GREENVIEW SUBDIVISION, RESUBDIVISION OF LOT 12, AND GREEVIEW SUBDIVISION, FIRST ADDITION, RESUBDIVISION OF LOT 12

APPLICATION NUMBER 8 DATE August 4, 2005

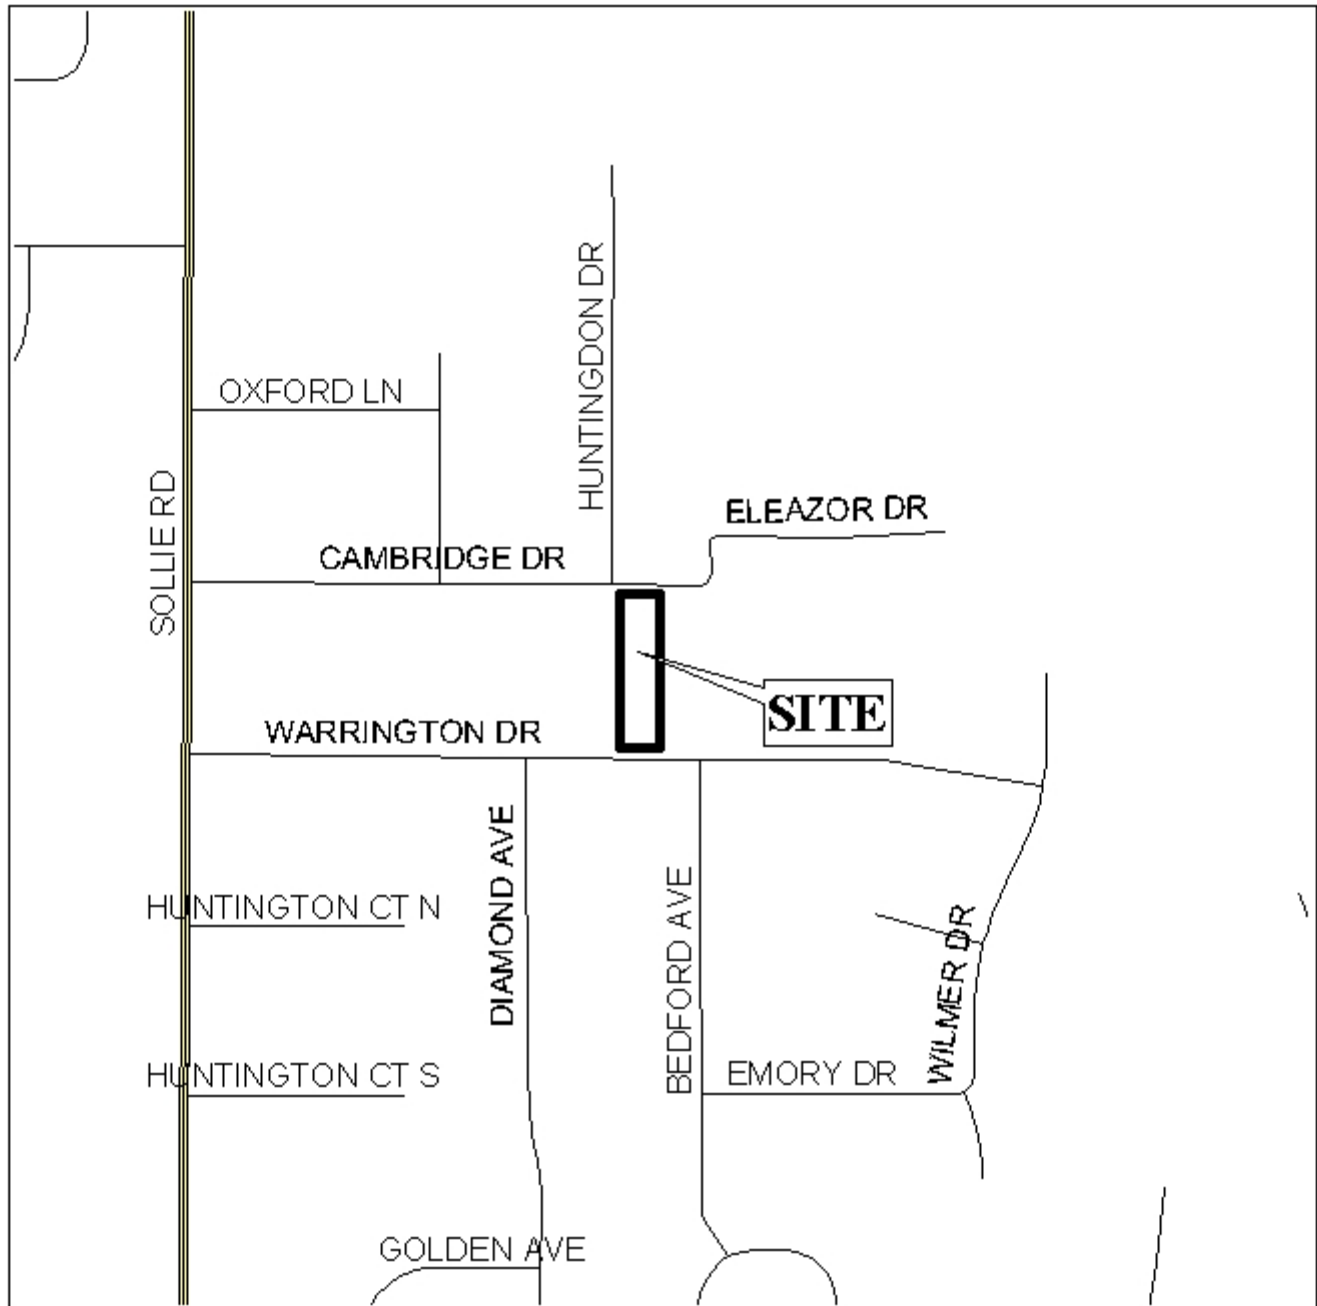
The plat illustrates the proposed 2 lot, 0.9 \pm acre subdivision which is located on the South side of Cambridge drive, 105' \pm West of its East terminus, extending to the North side of Warrington Drive, 75' \pm West Bedford Avenue. The subdivision is served by public water and individual septic systems.

The purpose of this application is to shift an interior lot line between two lots.

As proposed, Lots 1 and 2 would meet the minimum dimensions (15,000 square feet) for lot sizes with septic systems of the Subdivision Regulations.

This site is located in the County, thus a note should be placed on the final plat stating that any lots which are developed commercially and adjoin residentially developed property must provide a buffer, in compliance with Section V.A.7. of the Subdivision Regulations.

The plat meets the minimum requirements of the Subdivision Regulations and is recommended for Tentative Approval subject to the following condition: 1) the placement of a note on the final plat stating that any lots which are developed commercially and adjoin residentially developed property must provide a buffer, in compliance with Section V.A.7. of the Subdivision Regulations.
